SUB-GRADE INSPECTION

Location: 318 LEVRETT RD.

Sewage Disposal System for

**Wood Land Nominee Trust
318 Leverett Road
Amherst, MA**

PLAN SECTION
PUMP CHAMBER FABRICATION DETAILS
 NO SCALE

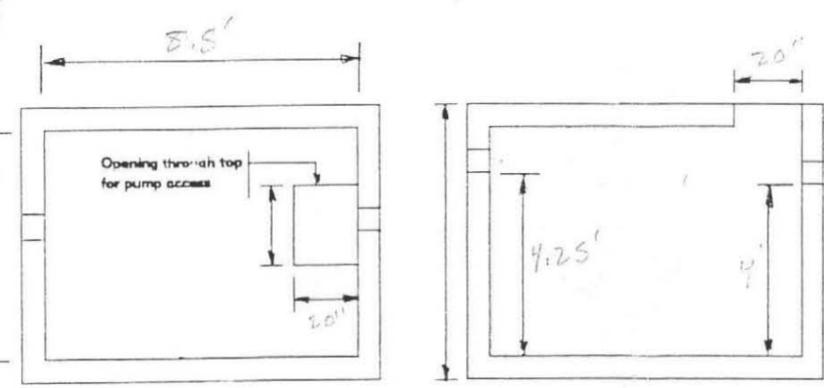
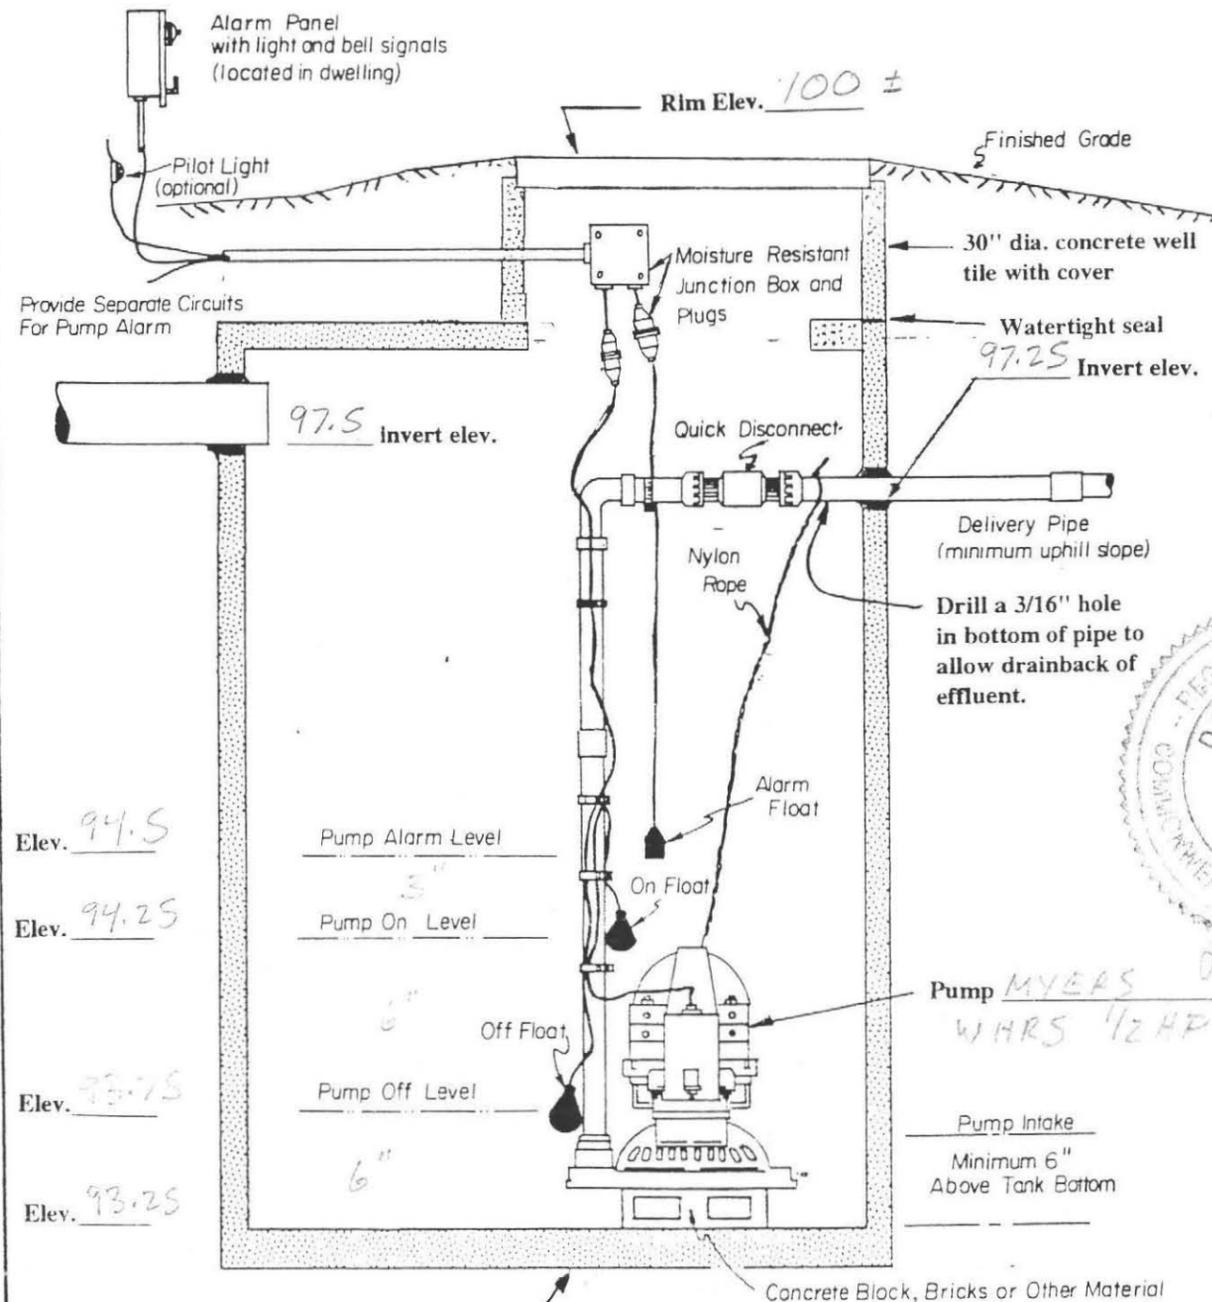
- Pump chamber needs buoyancy calculations, as does new septic tank if installed.
- Page 18 – missing elevations at foundation *OK*
- Must be sure that foundation drain is removed/relocated – engineer to verify *OK*

$$\begin{aligned} \text{TOP} &= 5.0(10.5)(0.8)(150) = 3937.5 \# \\ \text{BOTTOM} &= \text{''} = 3937.5 \# \\ (2) \text{ SIDES} &= 10.5(5.0)(0.8)(150)(2) = 7875 \# \\ (2) \text{ ENDS} &= 4.0(5.0)(0.8)(150)(2) = 3000 \# \\ \hline &= 18750 \# \end{aligned}$$

$$\begin{aligned} \text{WGT TANK TOP} &= 9.5(5.3)(.5)(150) = 3776.25 \# \\ \text{BOTTOM} &= \text{''} = 3776.25 \# \\ 2 \text{ SIDES} &= 5.4(9.5)(.5)(150)(2) = 7695.0 \# \\ 2 \text{ ENDS} &= 4.3(5.4)(.5)(150)(2) = 3483.0 \# \\ \hline &= 18730 \# \end{aligned}$$

NOTE: BOTTOM OF PUMP CHAMBER = ELEV. 93.0;
 MAX ESHGW @ CHAMBER = ELEV 94.25;
 NO CALCS REQUIRED.
